CITY of NOVI CITY COUNCIL

Agenda Item 3
February 4, 2008

SUBJECT: Consideration of Zoning Map Amendment 18.673 with Planned Rezoning Overlay (PRO) SP 07-59 from the applicant, the Basilian Fathers of Milford, Michigan, to rezone property located north of Eleven Mile Road, west of Taft Road from R-1, One-Family Residential to RM-1, Low Density, Low-Rise Multiple Family Residential and consideration of the PRO Concept Plan. The subject property is 4.15 acres.

Basilian Fathers Residence Planned Rezoning Overlay
Rezoning 18.673 SP #07-59

REDUCED CONCEPT PLAN

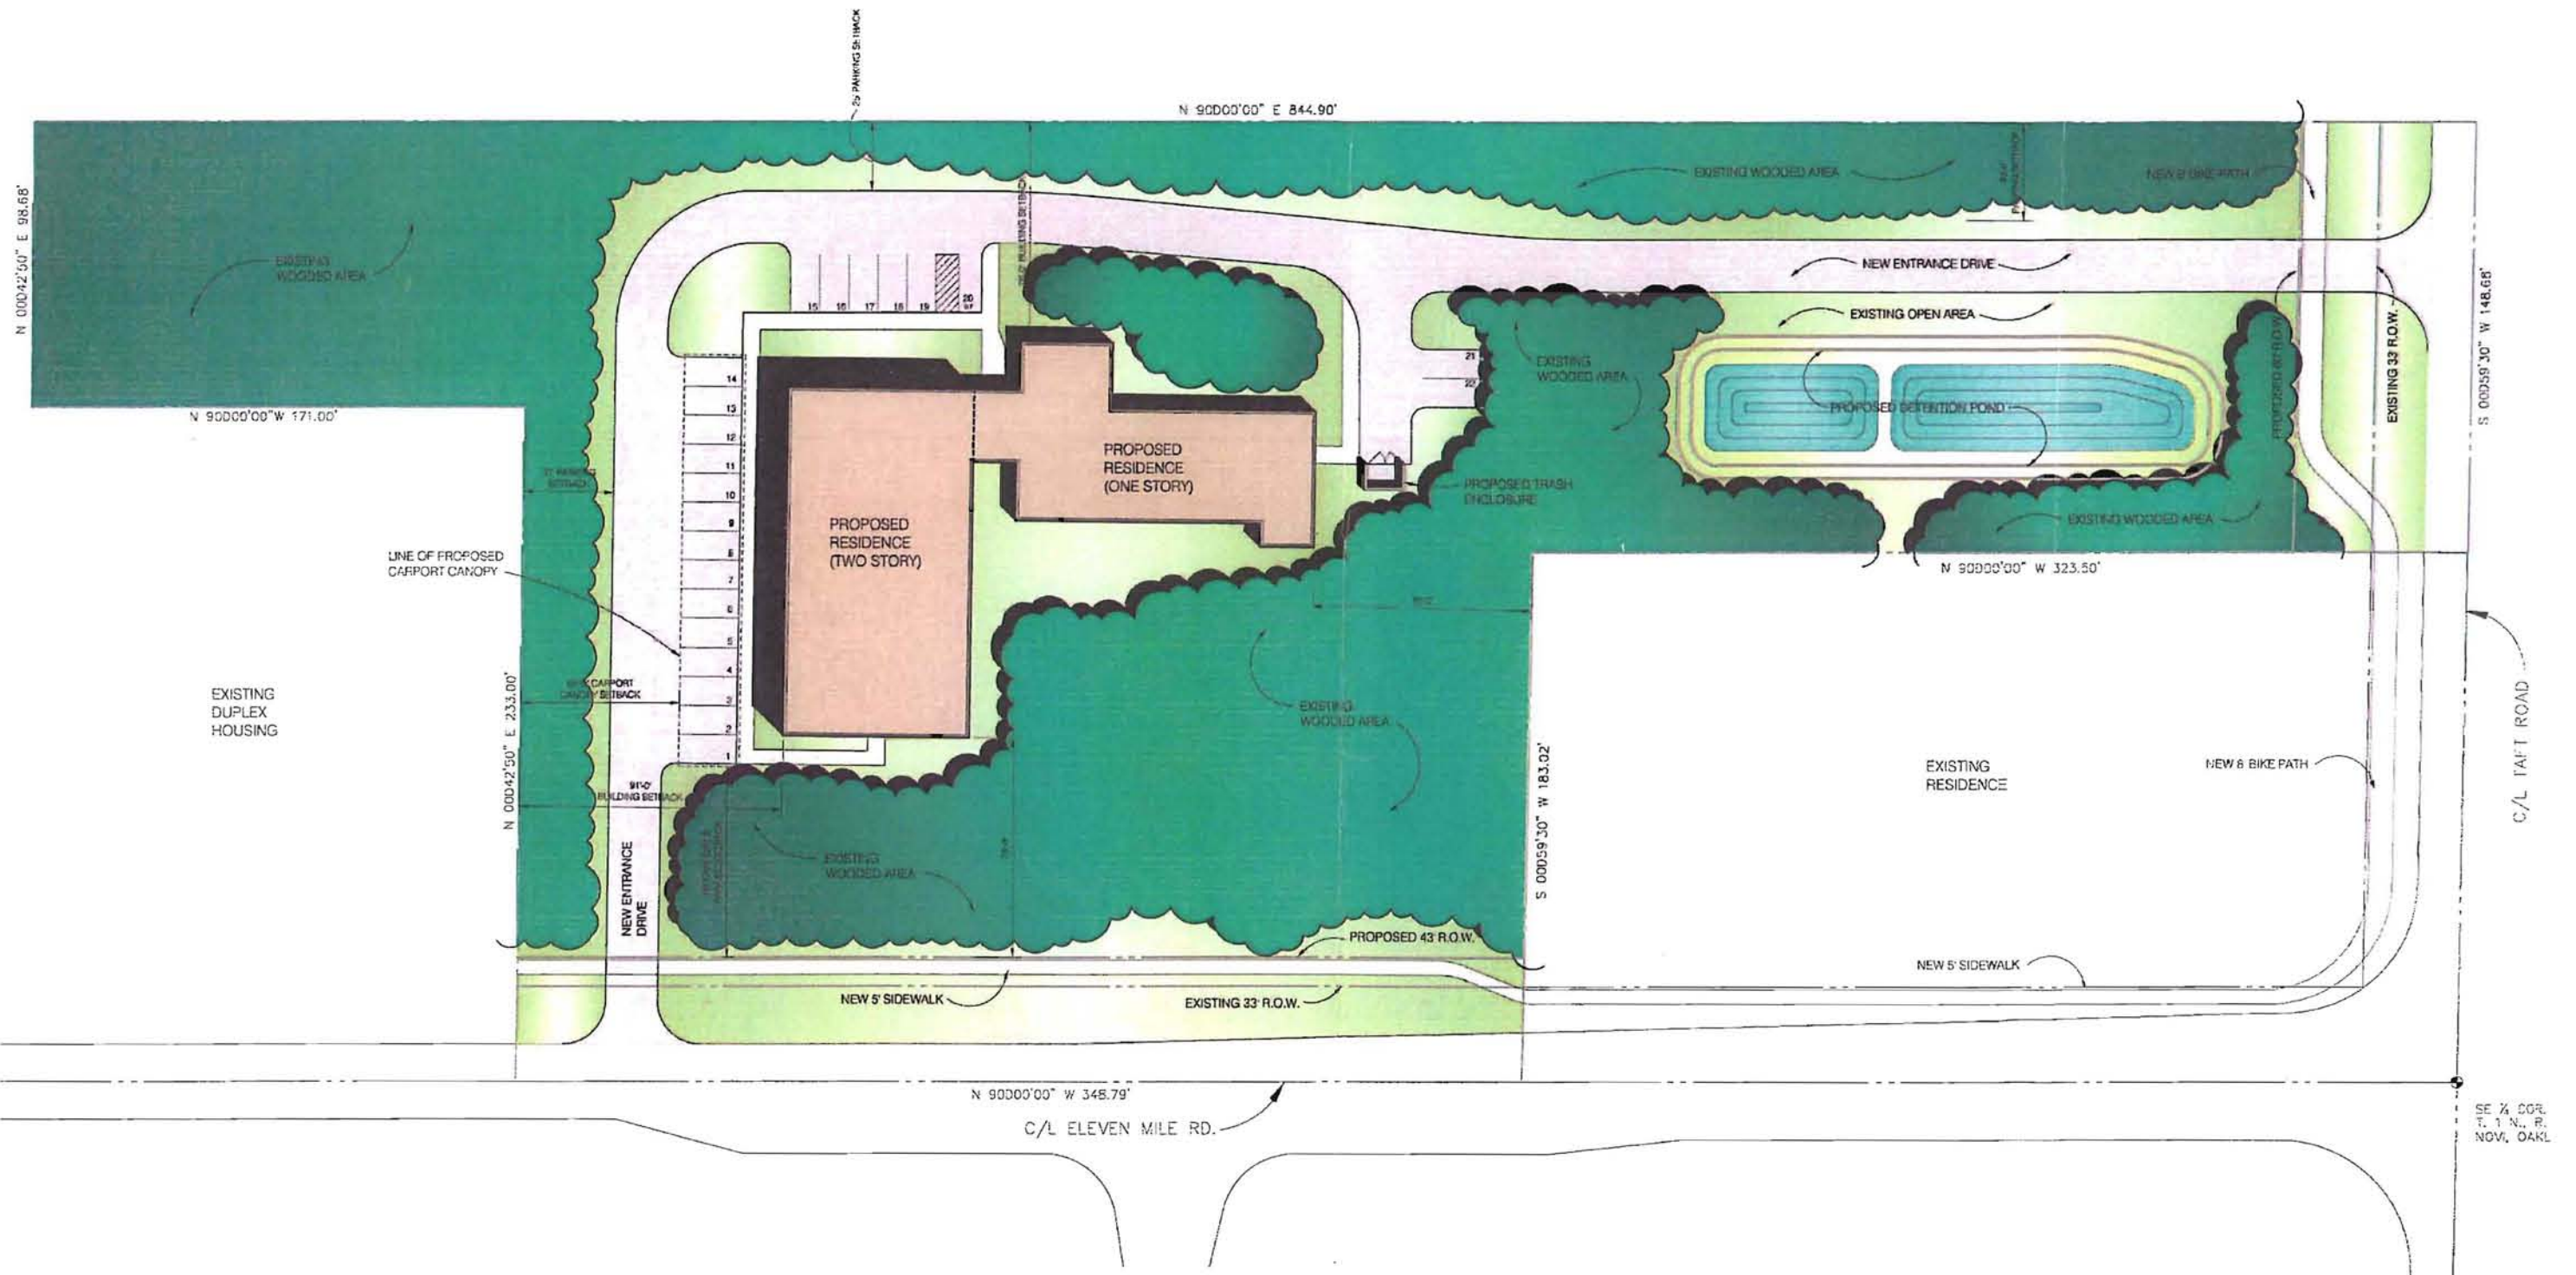
The applicant's revised concept plan shows a multi-story structure that is two stories tall on the western side of the building and one story tall on the eastern side of the building. The building itself is surrounded by associated landscaping and parking on the northern, eastern and western sides. The applicant has also added a carport to cover the proposed parking on the western side of the site and has added a dumpster near the eastern side of the site. The parking has also been increased from twenty spaces to twenty-two spaces as part of the revised concept plan and a detention pond has been included on the far eastern side of the property adjacent to Taft Road. The proposed location of the detention pond could result in the loss of additional regulated trees. Lastly, the applicant has included a five foot sidewalk along Eleven Mile Road and an eight foot pathway along Taft Road.

The Barrier Free Code indicates that one barrier free van accessible space should be provided for any parking area having one to twenty-five spaces. Twenty spaces are shown for the proposed residence. However, none of these spaces are barrier free. One barrier free van accessible space should be provided. **The applicant should indicate where this space will be provided on the response letter and a barrier free sign should be included on the plan.** The applicant may want to consider marking the 21' area on the north side of the building, just east of the center island as a van accessible space.

A five foot sidewalk is required along the Eleven Mile Road frontage and an eight foot sidewalk is required along the Taft Road frontage. The applicant has indicated that a sidewalk will be provided along Eleven Mile Road but has not indicated the size. No sidewalk is shown along Taft Road. **The applicant should show both required sidewalks on the plan and indicate the size of each sidewalk.**

3. All driveways within 200-feet of the property shall be shown on the plans.
4. A secondary access stub shall be provided to the undeveloped property to the north near the western limits of the proposed development.
5. The master planned 43-foot half right-of-way for Eleven Mile Road shall be shown on the plan.
6. The master planned 60-foot half right-of-way for Taft Road shall be shown on the plan.

14. If use of the Grand River District Regional Detention Basin is proposed, on site detention is still required for the bankfull flood volume. Aboveground storm water pretreatment will also be required. Currently, no storm water facilities are shown on the plan.

1. Location Map: Location map denoting the location of the proposed development should be provided on the site plan.
2. Sidewalk: Sidewalk should be provided on the frontage of the proposed development along both 11 Mile and Taft Roads. A walking path should also be provided to the proposed building from these sidewalks.

3. Master Plan Right-of-Way: The master plan Right-of-Way (ROW) width on 11 Mile Road and on Taft Road should be shown on the plan. We believe both are planned for 60' each side of the section line, for a total of 120' width. It would be beneficial if the developer would be willing to donate the additional 27' ROW from their frontage to the City of Novi at this time.

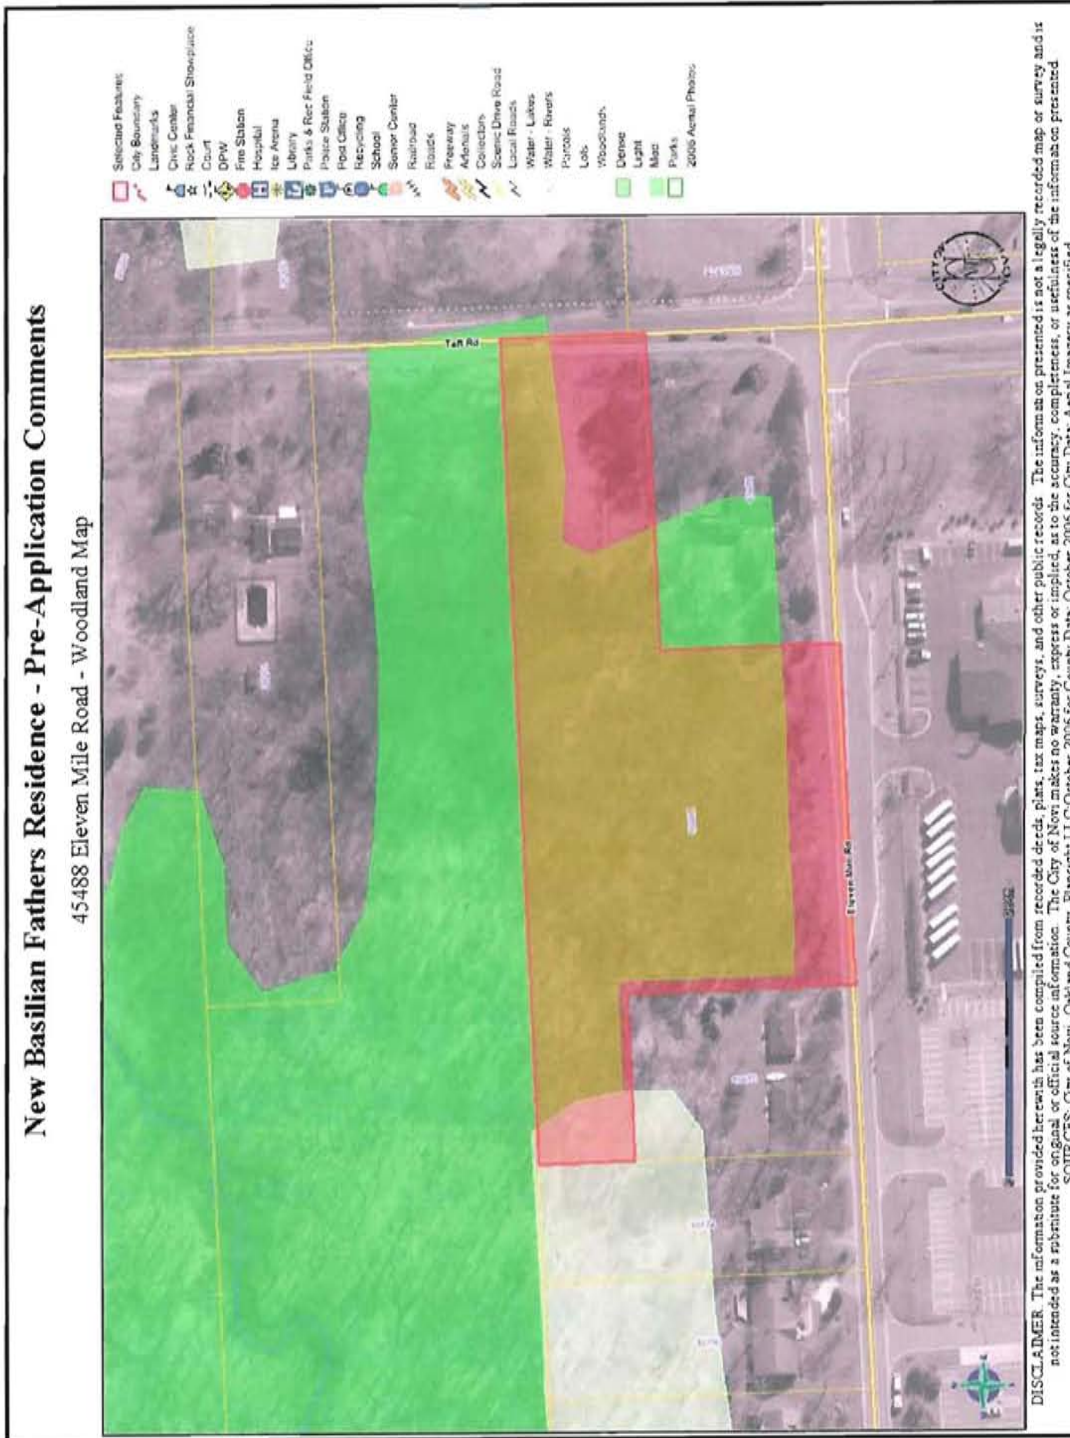
As shown, there appear to be substantial impacts proposed to regulated woodlands associated with the proposed site improvements. It appears as if the proposed work (proposed buildings, proposed parking areas and access drive from Taft Road) will likely involve substantial impacts to the Regulated Woodlands located on this parcel. The plan does not currently indicate and label regulated Woodland Boundaries. In addition, the proposed Conceptual/P.R.O. Plan does not appear to be significantly different from the Pre-Application Plan that was previously reviewed by our office.

Proposed impacts to any trees within these Regulated Woodland areas will require a Woodland Permit from the City of Novi that allows for the removal of trees eight (8)-inch diameter-at-breast-height (d.b.h.) or greater. Such trees shall be relocated or replaced by the permit grantee. All replacement trees shall be two and one-half (2 ½) inches caliper or greater.

An existing tree survey has not yet been submitted. ECT recommends that we conduct a woodland field verification at the time of Preliminary Site Plan submittal in order to verify existing regulated tree locations and confirm any proposed tree replacement quantities. A tree inventory and Woodland Plan shall be provided in the Preliminary Site Plan.
